## **SERVICE BULLETIN #260**

**MODELS:** BE GASOLINE GENERATOR MODELS 8.0BEG – 15.0BEG and 8.0SBEG – 14.0SBEG

SUBJECT: WIRE COLOR CHANGE AND AC VOLTAGE REGULATOR CHANGE

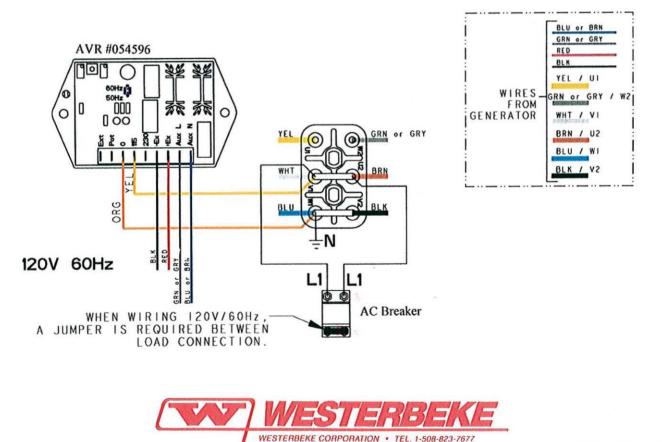
The GREEN wire that attaches to the AC voltage regulator and the GREEN AC output wire from the generator that attaches to the AC terminal block located in the control box of the generator have changed. They are now GRAY wires.

Along with this wire color change a newly designed AC voltage regulator pn#054596 is being implemented. It is connected to a new auxiliary winding that is now part of the generator. The new voltage regulator #054596 **can not** be used in earlier model BE generators that use the #046446 voltage regulator. However the #046446 voltage regulator can be used in a later model BE generator that has the new auxiliary winding.

Illustrations below and on the back of this bulletin show voltage regulator connections and AC terminal block configurations for 120 and 120/240 volt 60 hertz and 230 volt 50 hertz.
